January 11, 2023 ADDENDUM NUMBER TWO Project No. ENG2201760232 For Department of Natural Resources

Drawing Revisions - Sheet C-2 Revision 1 (attached)

SCALE: 1" = DRAWN BY: CHECKED BY DATE: DECE Revision D 1	ARC/ : AR	C 09,	2022	ate -01	-11
FILE NO: 22-12509 CLIENT NAME: INDIANA DEPARTMENT OF NATURAL RESOURCES					
PROJECT DESCRIPTION: PATOKA SOUTH BOAT RAMP IMPROVEMENTS SHEET TITLE: SITE PLAN					
DESIGN PHASE: FINAL PLANS SHEET NUMBER:

Pre-Bid Meeting Agenda: Patoka Reservoir South Ramp Parking Lot Expansion and Resurfacing

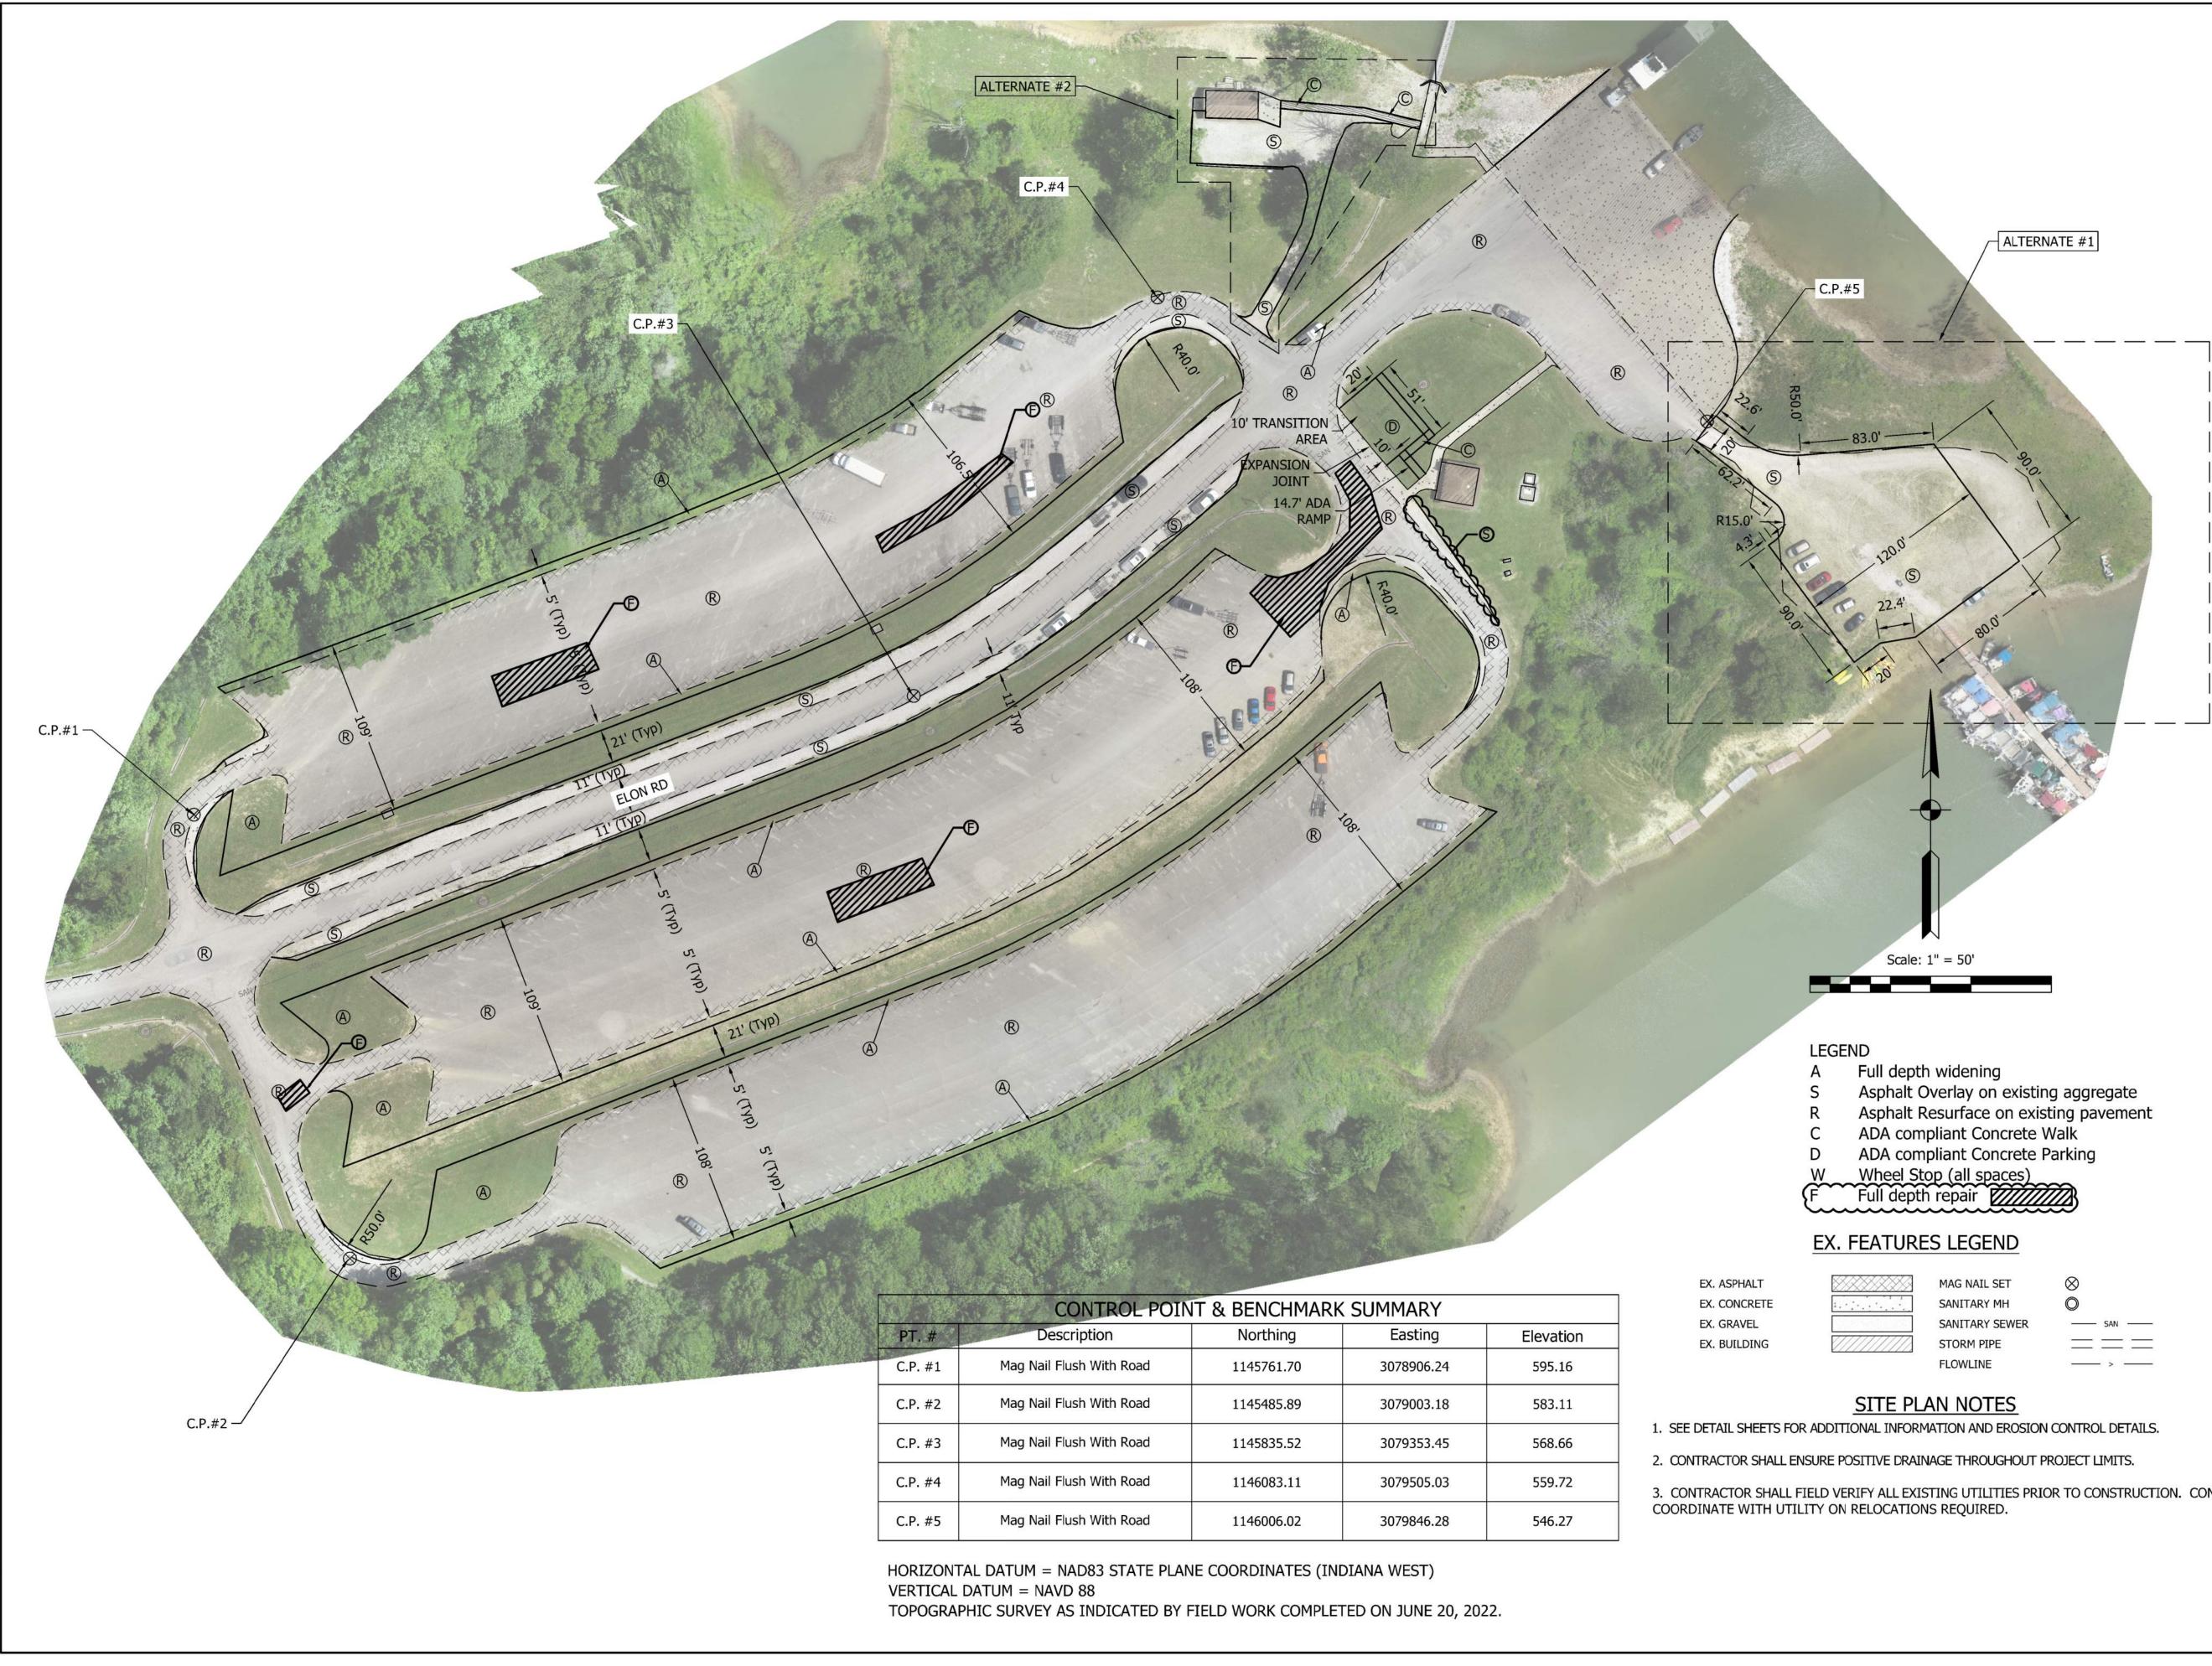
ITEM NO. 1 – Update to plan sheet to include Full Depth Repair locations within Base Bid resurfacing.

ITEM NO. 2 – Update to plan sheet to include clarification of improvements to existing aggregate area adjacent to restroom facility.
